1992 - 1993 Corvette: Recall: Power Steering Gear Inlet Hose

Subject: PRODUCT SAFETY CAMPAIGN 93CO2 - POWER STEERING GEAR INLET HOSE

Model and Year: 1992-93 CHEVROLET LT1 CORVETTE

Bulletin Number: 93C02

Figures on page 4 may assist in performing this repair procedure.

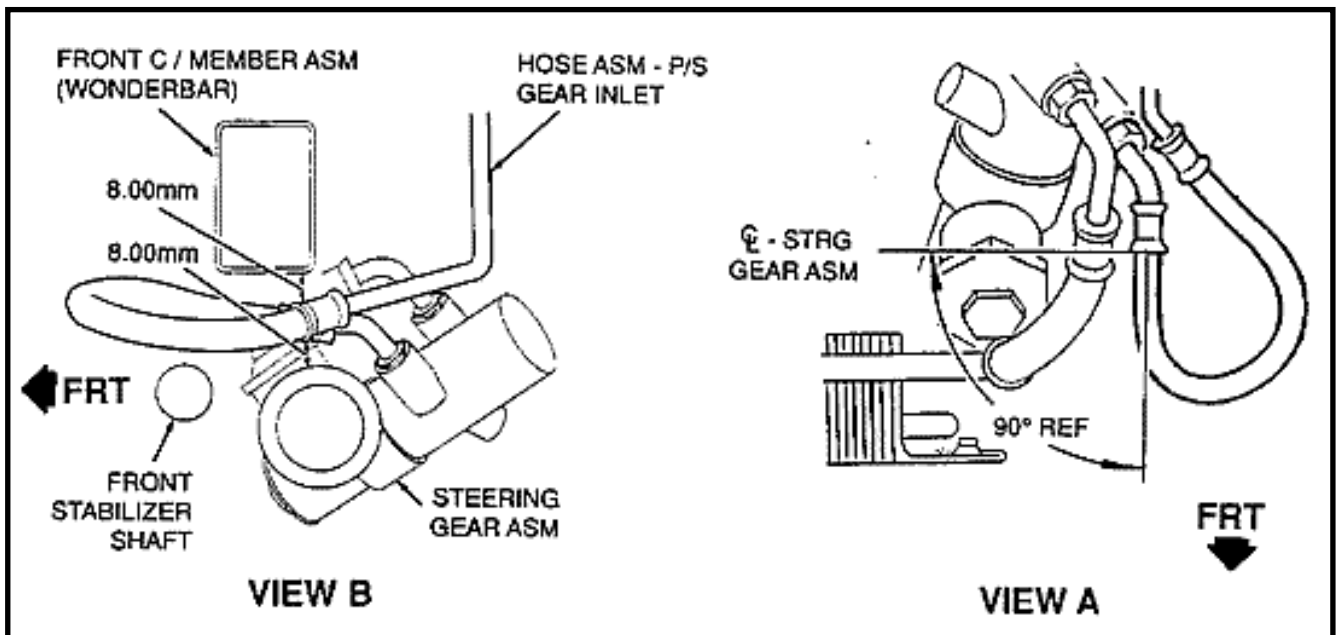
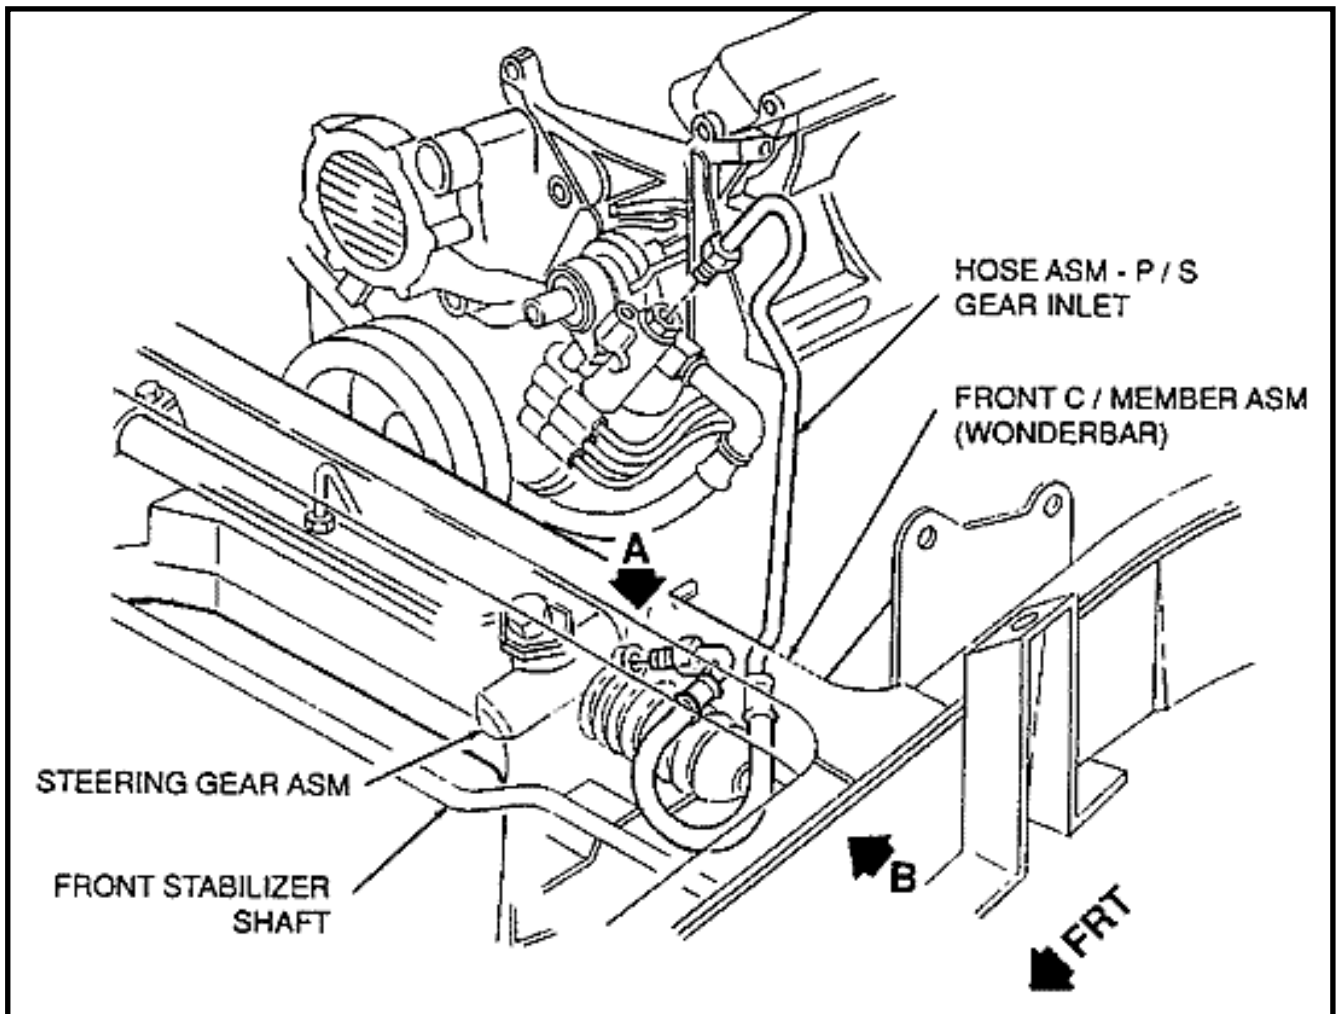
1. Install new power steering gear inlet hose following procedures on page 3B-6 of either

the 1992 Corvette Service Manual (ST-364-92-1) or the 1993 Corvette Service Manual (ST-364-93PSID).

Notice: Be certain to leave adequate clearance between front cross-member and hose/pipe assembly. View B on page 4 illustrates proper clearance.
